MARK	DATE	DESCRIPTIONS	BY	CH'D	CCO#
2	04/16/07	CABLE SYSTEM	GB	MN	37
1	01/31/07	WEST DEVIATION SADDLE GEOMETRY	AS	MN	15

CONTRACT CHANGE ORDER NO. 37
SHEET 9 OF 21

SAN FRANCISCO OAKLAND BAY BRIDGE
EAST SPAN SEISMIC SAFETY PROJECT
SELF-ANCHORED SUSPENSION BRIDGE (SUPERSTRUCTURE & TOWER)

SUSPENSION CABLE LAYOUT NO. 3

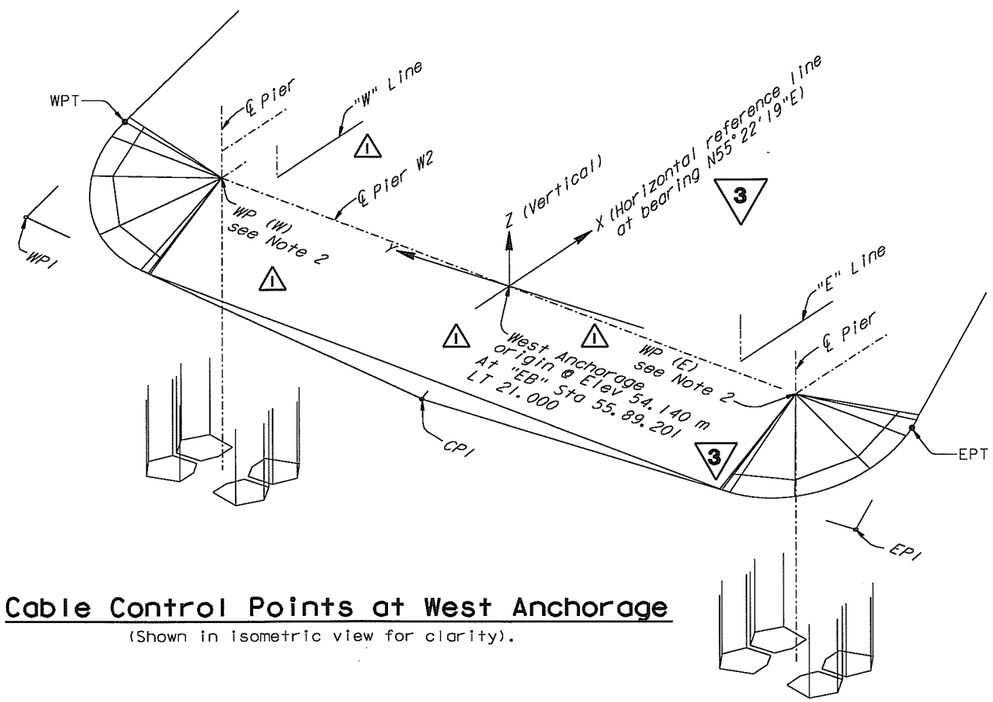
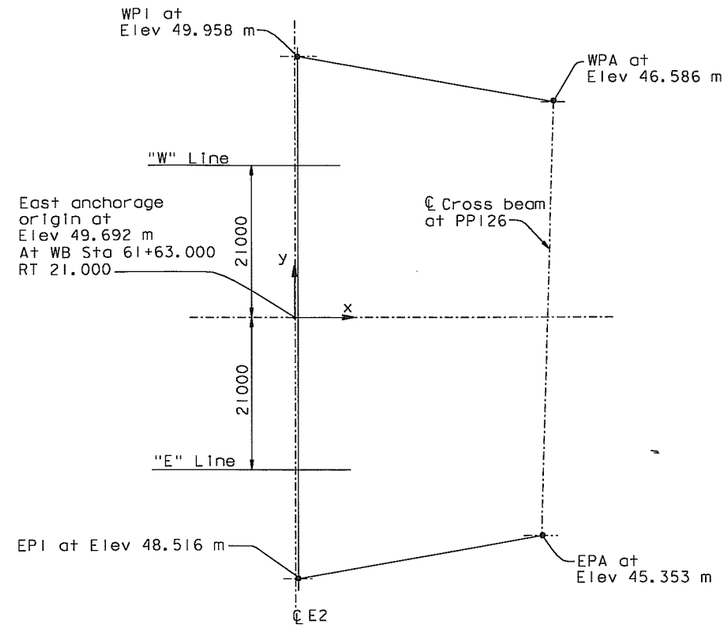
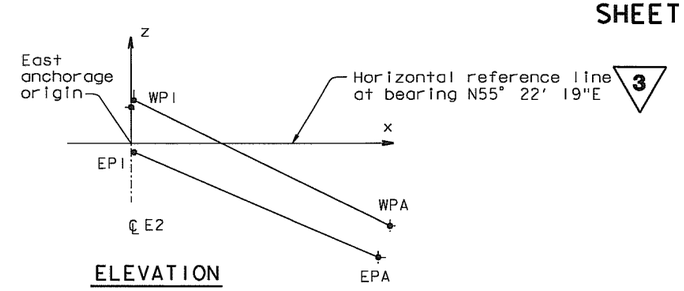
REVISED PER ADDENDUM NO. 3 DATED NOVEMBER 7, 2005

1. At the west anchorage the cable profile shall be determined from the EPT and WPT. Geometry of saddles shall conform to EP1, WP1 and CP1.
2. WP(W) & WP(E) do not coincide with ℄ Pier W2, ℄ Pier W2E nor ℄ Pier W2W.

SUSPENDER BRACKET DETAILS NO. 3

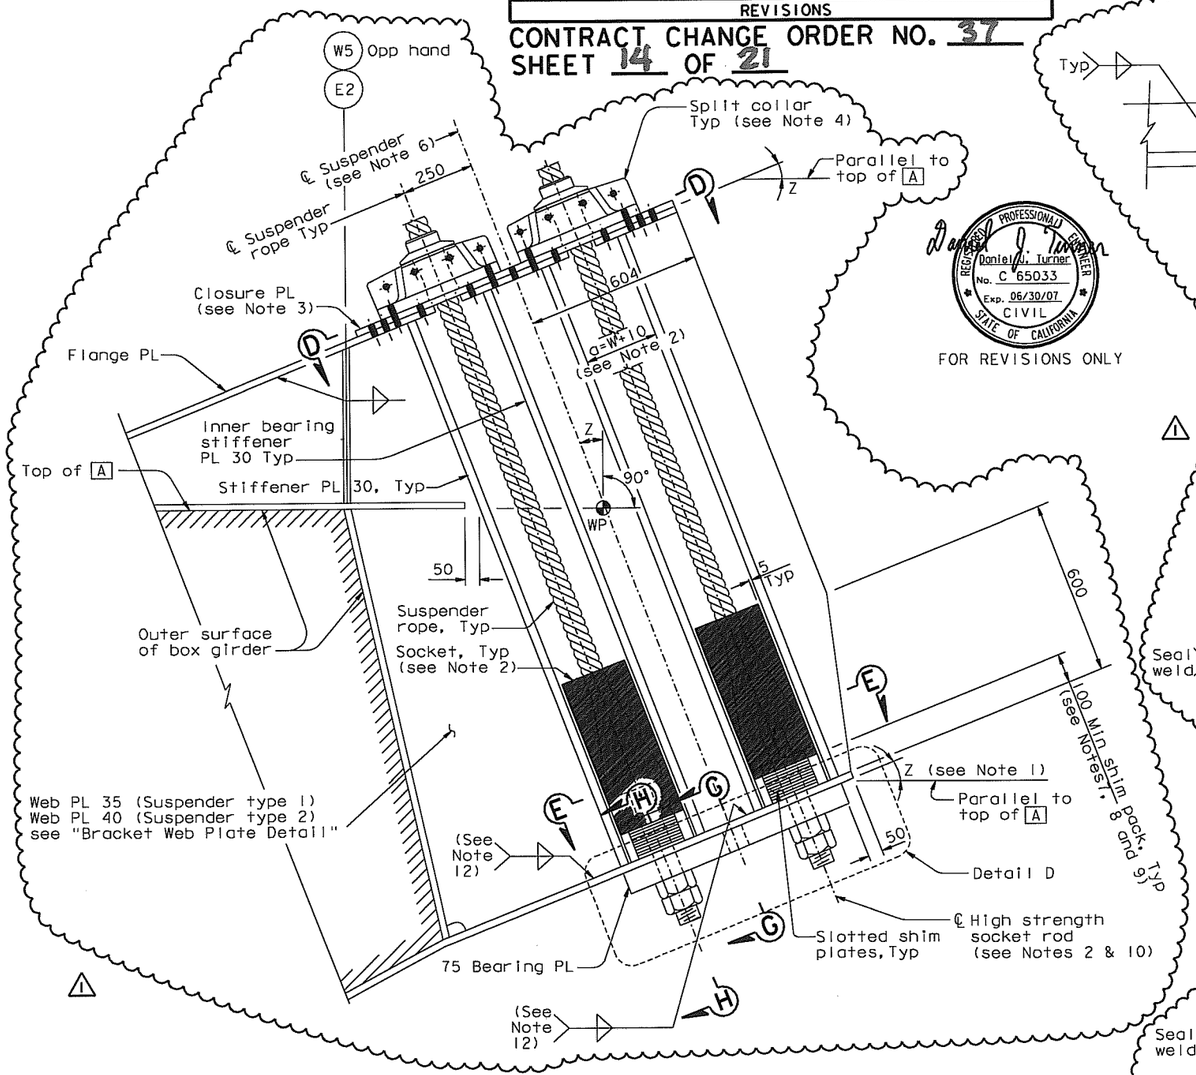
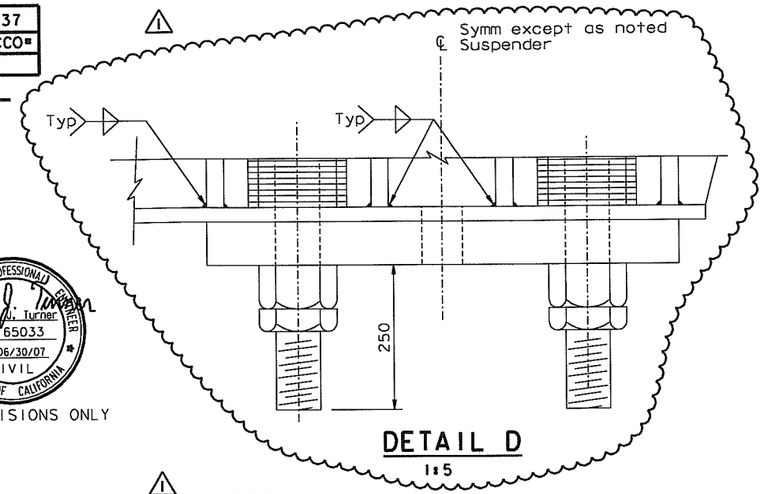
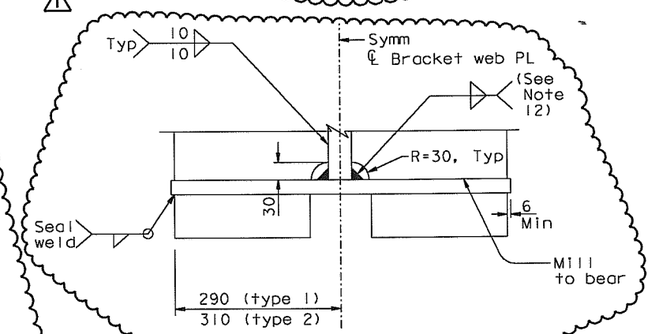
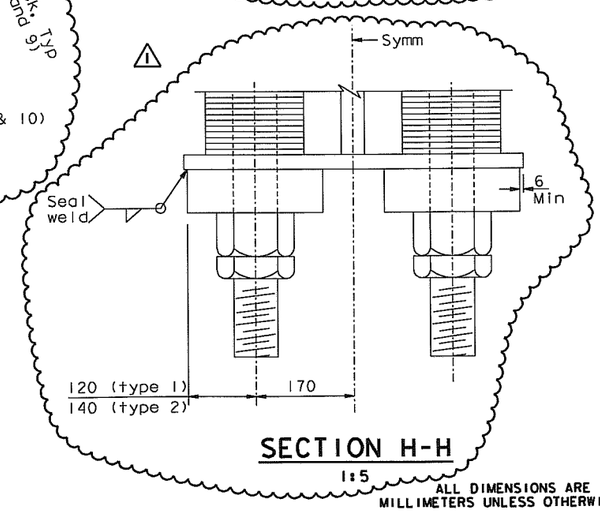
4 REVISED PER ADDENDUM NO. 4 DATED DECEMBER 9, 2005

SUSPENDER BRACKET DETAILS NO. 4

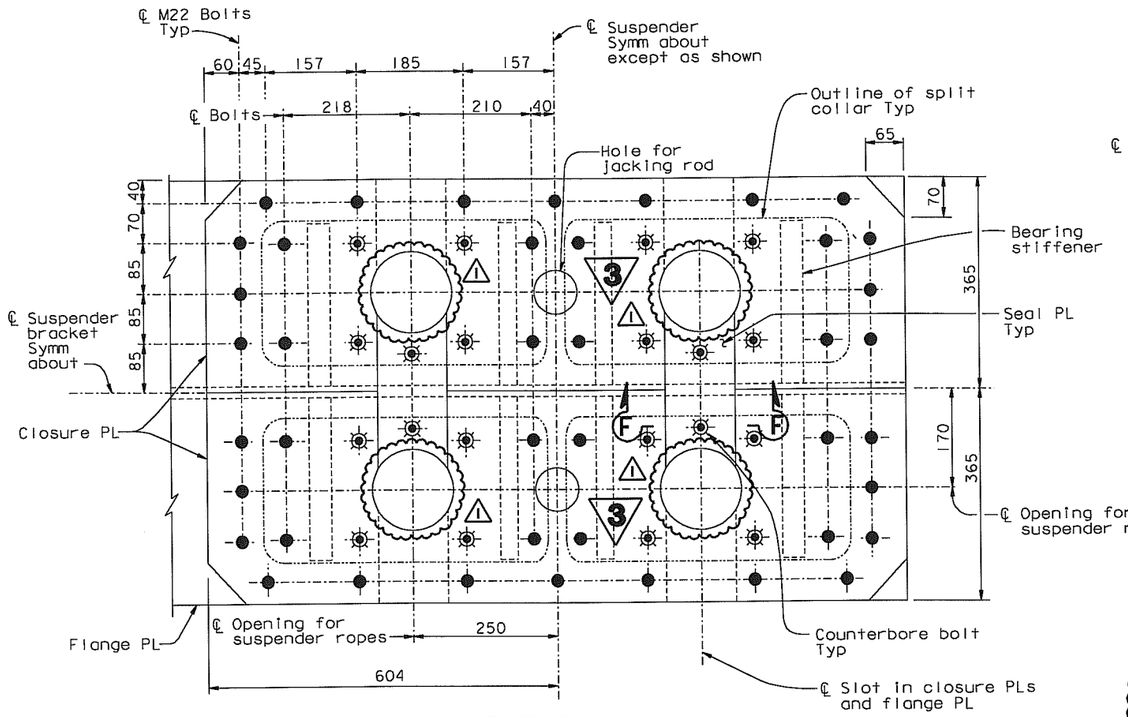
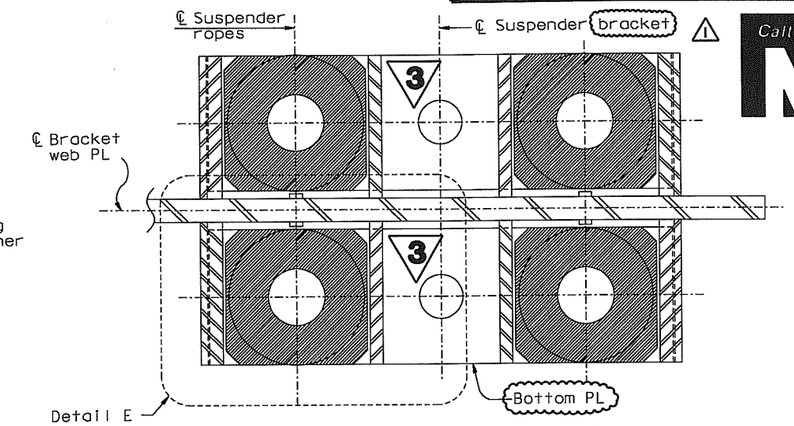
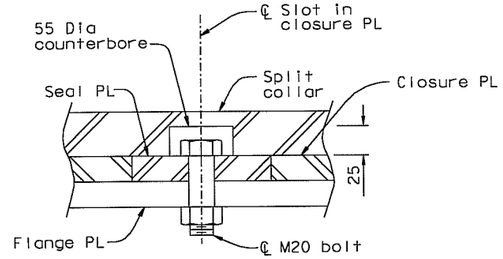
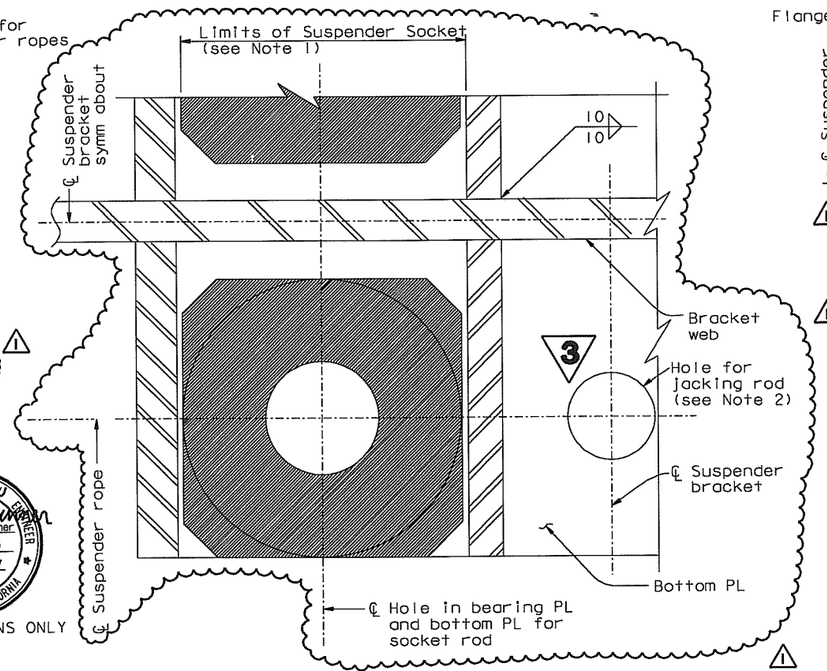
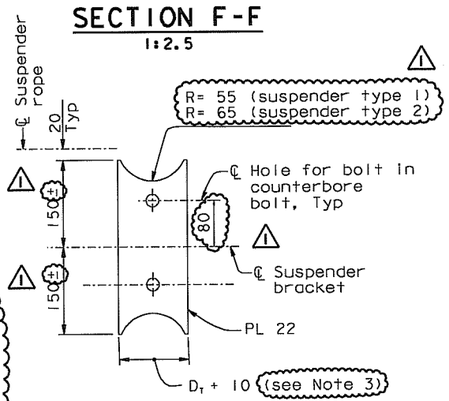
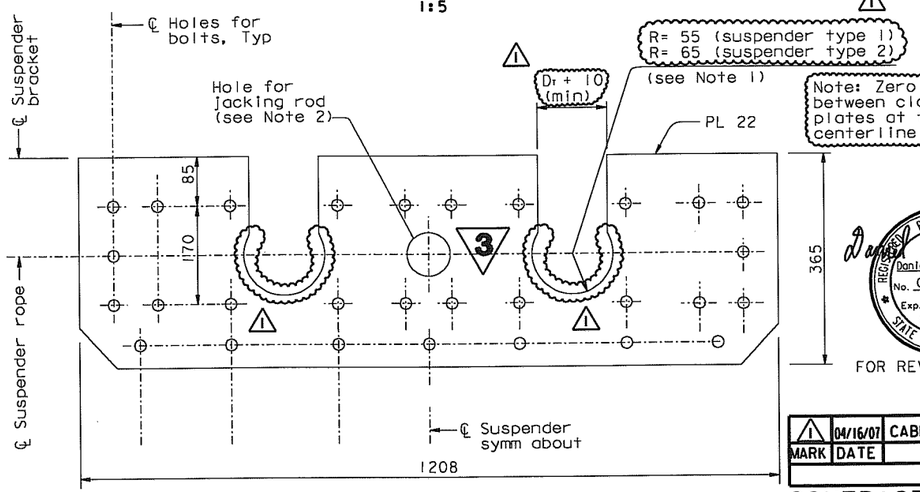
3 REVISED PER ADDENDUM NO. 3 DATED NOVEMBER 7, 2005

SUSPENDER BRACKET DETAILS NO. 6

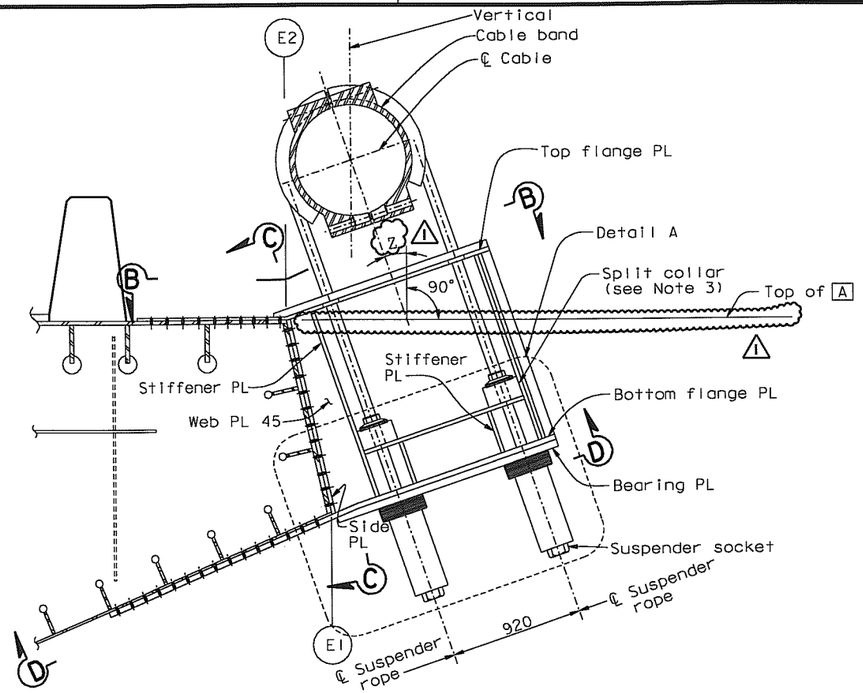
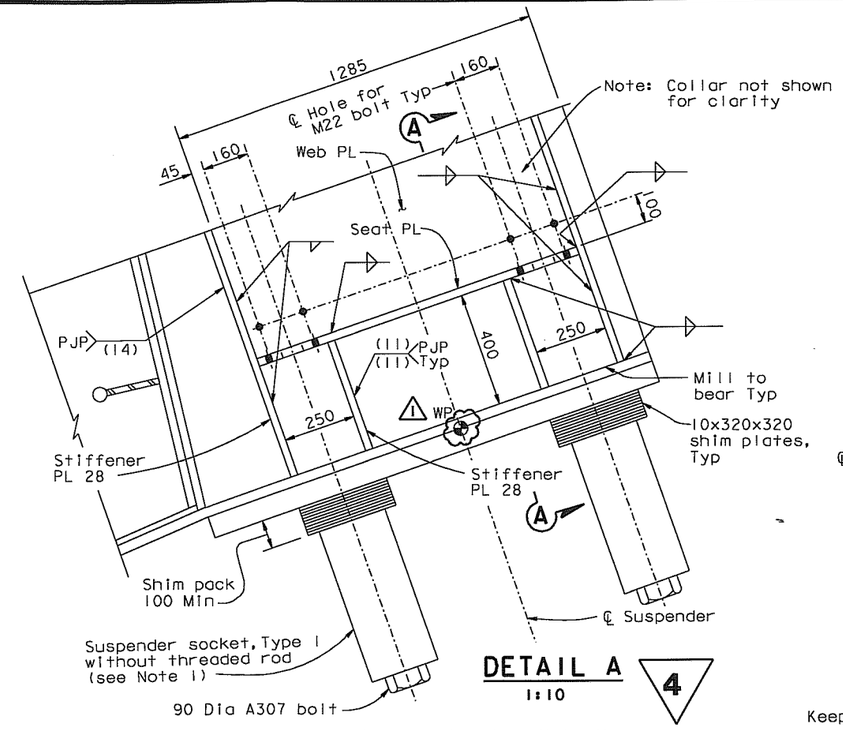
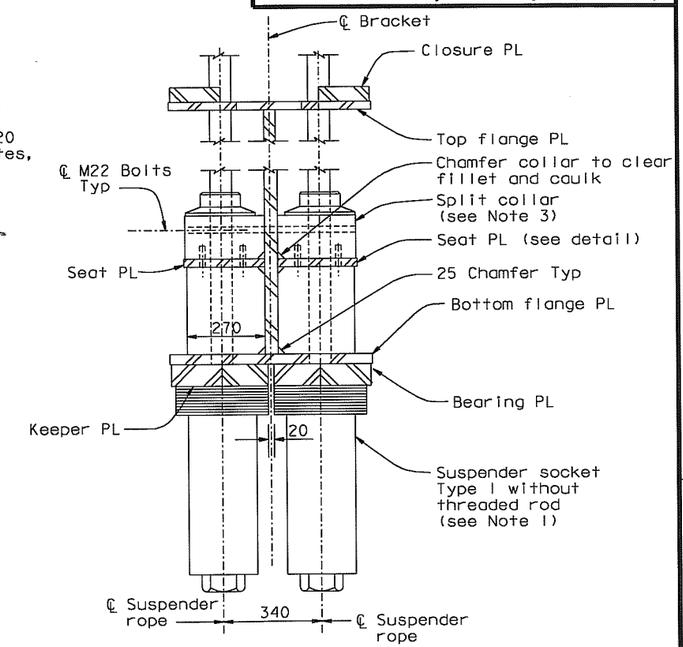
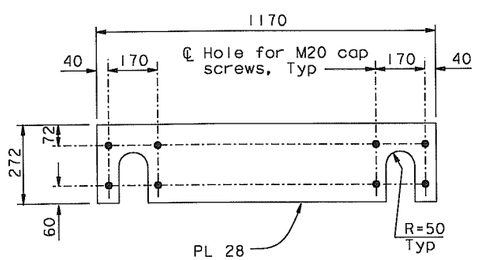
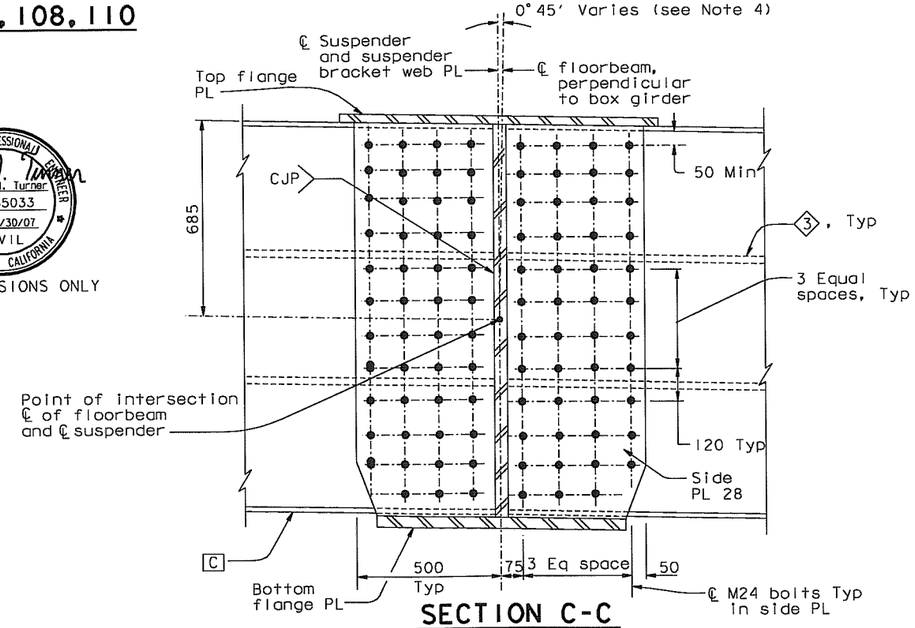
4 REVISED PER ADDENDUM NO. 4 DATED DECEMBER 9, 2005
